HEBER PUBLIC UTILITY DISTRICT

ADDENDUM NO. 1 for
HPUD RECREATION CENTER PROJECT
Project No. 744.077E

October 1, 2019

F1 FLOOR PLAN
SCALE: 3/8" = 1'-0"

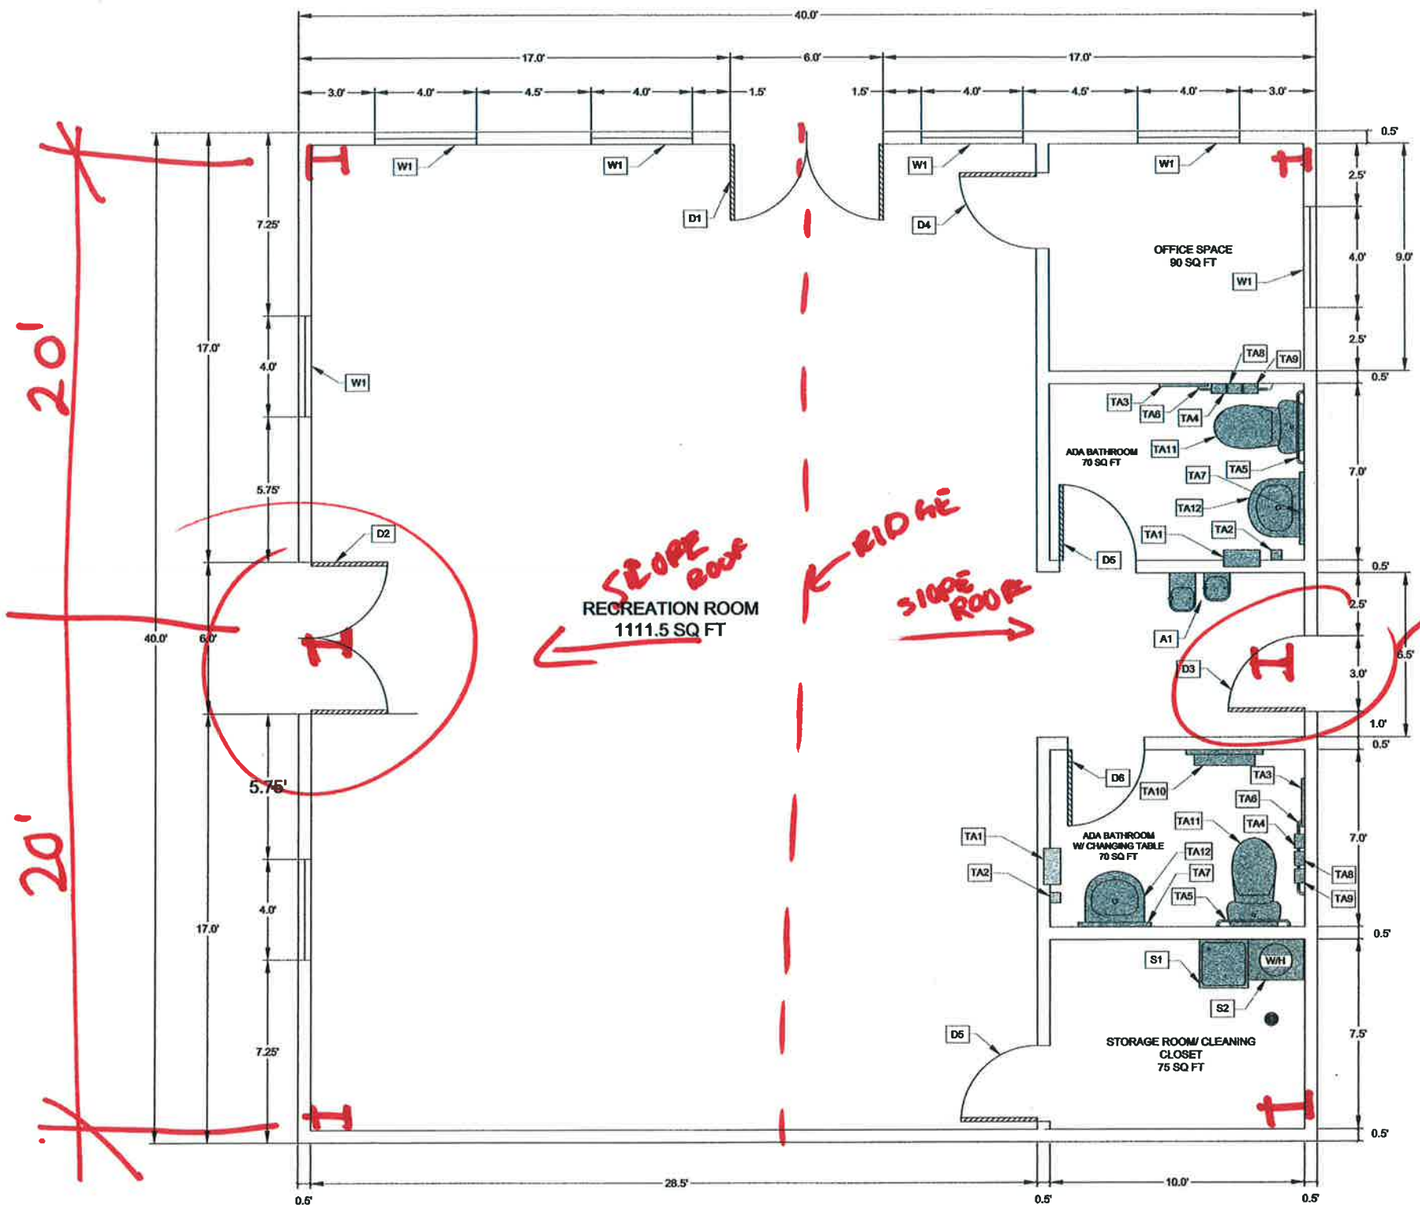
Question #3: The design of the floor plan doesn't work with metal building. Please see attached exhibit. See attachment "Addendum 1 – Attachment A." Please let me know you will like to send a revised floor plan or let us know how to proceed.
Response #3:
Regarding the exterior access door on the north end of the building: The office room may be enlarged and the storage room may be decreased to avoid conflict between the exterior access door and the column location as required by the building design.
Regarding the exterior access door on the south end of the building: The door location may be adjusted to allow for column location as required by building design.
